Support Document for the Revised National Priorities List Final Rule – Bremerton Gasworks

**Support Document for the
Revised National Priorities List
Final Rule
Bremerton Gasworks
May 2012**

**Site Assessment and Remedy Decisions Branch
Office of Superfund Remediation and Technology Innovation
Office of Solid Waste and Emergency Response
U.S. Environmental Protection Agency
Washington, DC 20460**

Figure 1 – Map of the Bremerton Gasworks area showing property boundaries, former features, sediment sample locations and the approximate location of the Organo-Clay Mat.

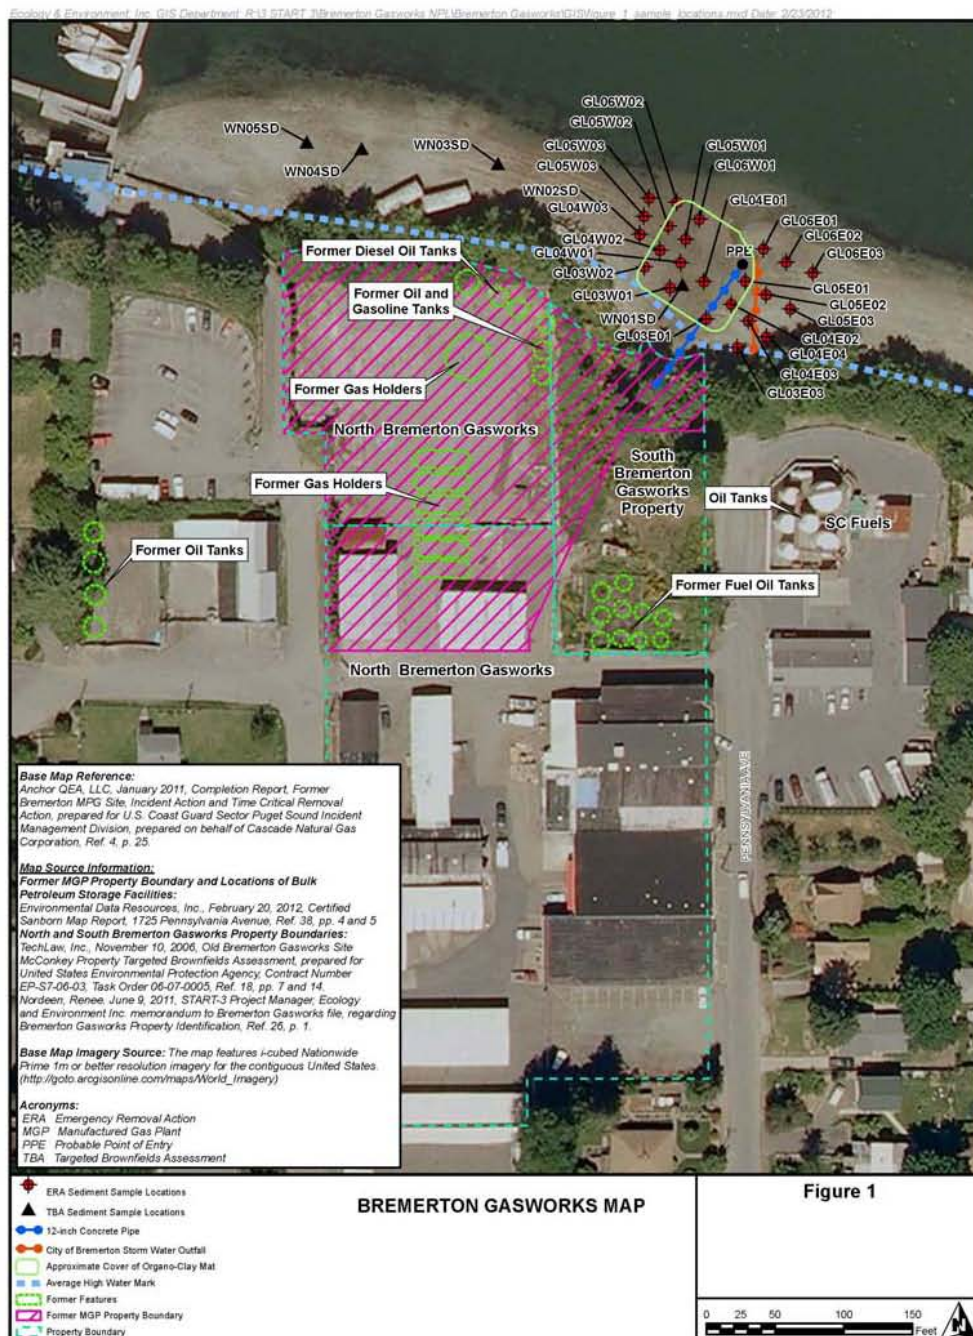
Page 7, 2nd paragraph and Figure 1

Comment: Cascade requested that the parcels identified in the referenced sentences and Figure 1 in HRS documentation record at proposal that comprise the former Bremerton MGP property be re-named by actual owner name and to make this change throughout the HRS documentation record at proposal. The commenter also requested that a new Figure 1 from the HRS documentation record at proposal be included to reflect the actual boundaries of the property associated with the former Bremerton MGP.

Response: The HRS documentation record has been revised at promulgation to reference the actual owner name of each of the parcels that comprises the former Bremerton MGP. Reference 37 has been added to the HRS documentation record at promulgation to clarify property boundaries. Figure 1 was not revised to include actual property owner names; however, property boundaries were confirmed.
